northern  
beaches  
council

## MEMORANDUM

**SUBJECT:** 117 Seaforth Crescent, Seaforth

**REFERENCE:** Deferral of DA2021/2313

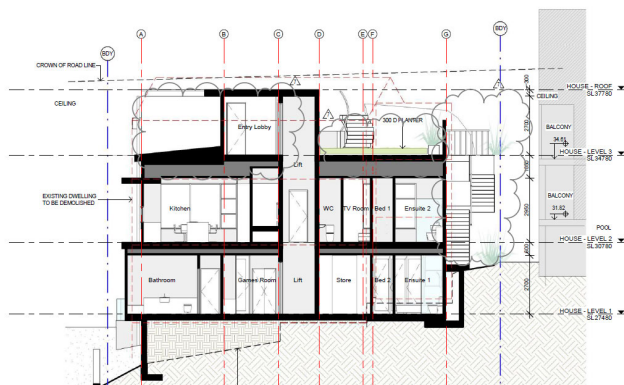
- 1. The deletion of the music room and the void area at level 3 as identified in purple on the floor plan below.**

- 2. The parking area to the south of the bin and bike store at level 3 is to be deleted and replaced with a green roof as identified in green on the floor plan below. This may require a redesign and relocation of the bin and bike store.**

- 3. A planter box with a minimum width of 500mm shall be provided across southern edge of level 3 as identified in blue on the floor plan below.**

- 4. All excavation works between the proposed dwelling house and southern boundary for the proposed external stairs and retaining wall is to be deleted, with existing ground**

The amended plans have deleted the music room and the partial void area specified in the NBLPP minutes, and therefore satisfactory.

The parking area to the south of the of the bin and bike store has been replaced with a green roof as part of the amended plans, in accordance with the above recommendation. It is noted that the proposed bin area will not be accessible with the green roof replacing the hardstand area. It is recommended via condition of consent that an access path to the bin storage area from the garage/dwelling house entrance is provided.

The amended plans include a planter box along the southern edge of level 3 in accordance with the above recommendation.
